Form 3160-5 (August, 2007)

Marbob Energy Corporation proposes to plug & abandon this well.

NMLC-028784B: Burch Keely Unit #68

RE: Plugging and Abandonment Procedure, Conditions of Approval

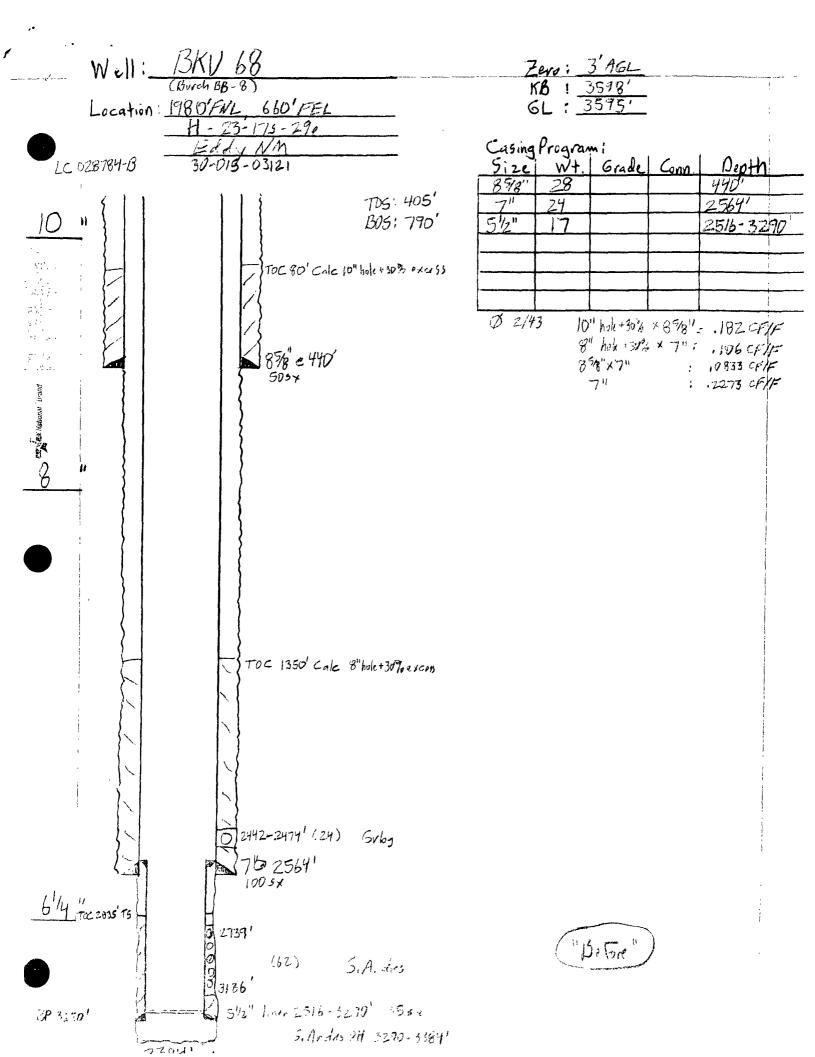
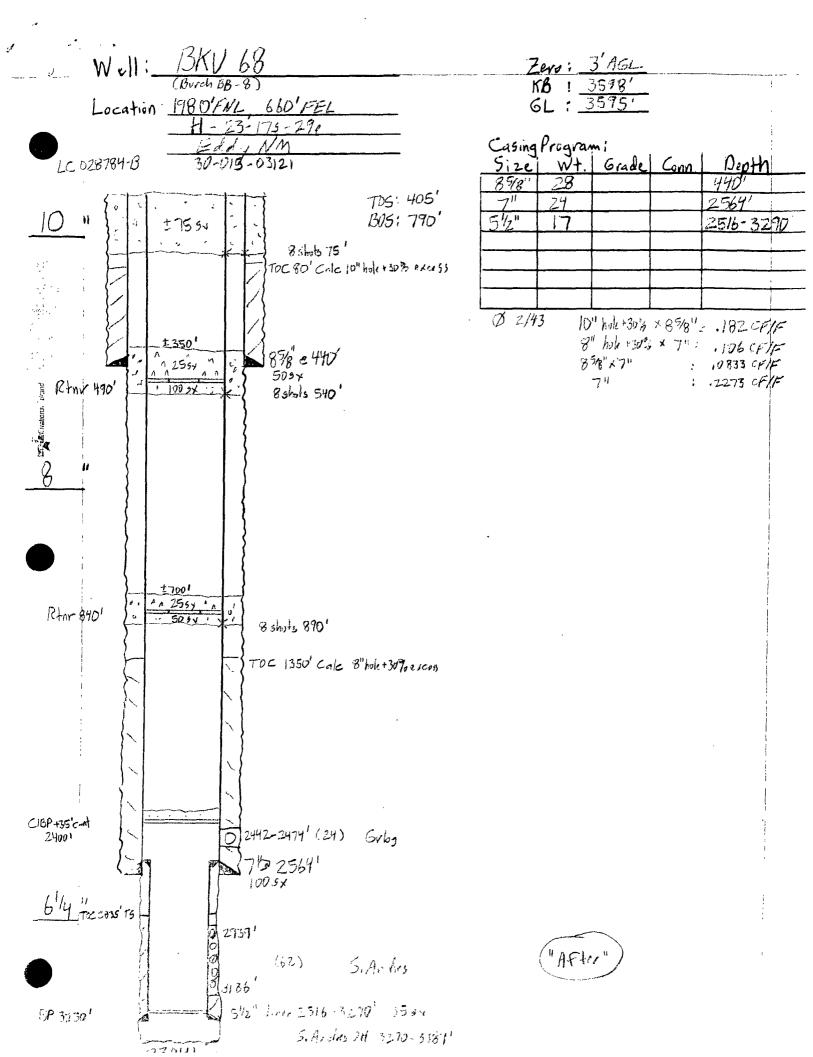
- 1. OK
- 1a. Drill out bridge plug at 3250 and spot plug from TD (3384') to 3240'. (Open Hole Casing shoe)
- 1b. Set CIBP at 2880' and bail 35' or pump 25 sx on top.

- 2. CHANGE: Perf 5-1/2" at 2614' and squeeze a plug to the top of liner and spot on inside of casing from perfs up to 2392'. If injection cannot be established, spot plug 50' below the perfs. WOC and tag at 2392' or shallower. (Casing shoe Top of liner Perfs San Andres)

- 3. OK >
- 4. CHANGE: Perf at 840' and squeeze a 110' plug (minimum 25 sx). If injection cannot be established, spot plug 50' below the perfs. WOC and tag at 730' or shallower. (BOS)

- 5. CHANGE: Perf at 490' and squeeze a plug in and out to 335'. If injection cannot be established, spot plug 50' below the perfs and refer to step 5a. WOC and tag at 335' or shallower. (Casing shoe TOS)

- 5a. Contingency Plug If injection rate was not established on above plug, perf and squeeze 100' above the tagged depth. Plug is to be a minimum 100' and 25sx.

- 6. CHANGE: Perf at 75' and squeeze a plug in and out to surface. If injection cannot be established, spot plug 50' below the perfs, and 1" annulus.
- 7. OK
